Access Compliance Report

Public Rights-of-Way

(Pedestrian Signals)

Intersection ID: N/A	Main Street:	Cross Street: N/A	Location: N/A
ADA ID: 51C403FB66F3	Signal Type: One Push Button-Non APS	Overall Compliance: No	Severity Score: BTN 1: N/A BTN 2: N/A No BTN: N/A
Codes/Mitigation Info/Possible Solution		Field Measurements/Component Compliance

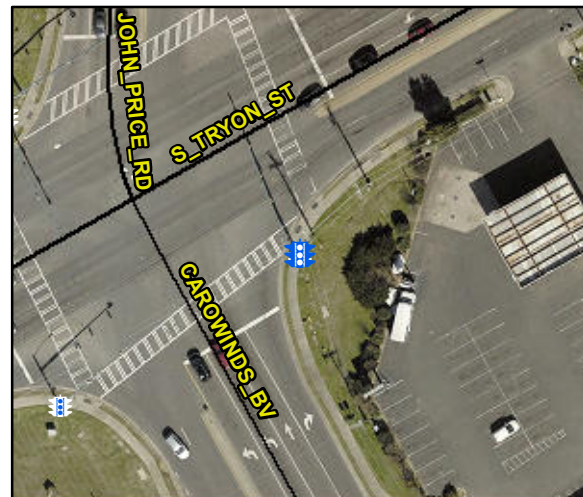
Surveyor Notes: TX HEIGHT 3/8

PROW/ADA: R410.6, TMUTCD 4e.08, R404.2, R406.2

Possible Solutions: Replace Signal Push Button With APS Button on New Post. Remove & Replace Sign.
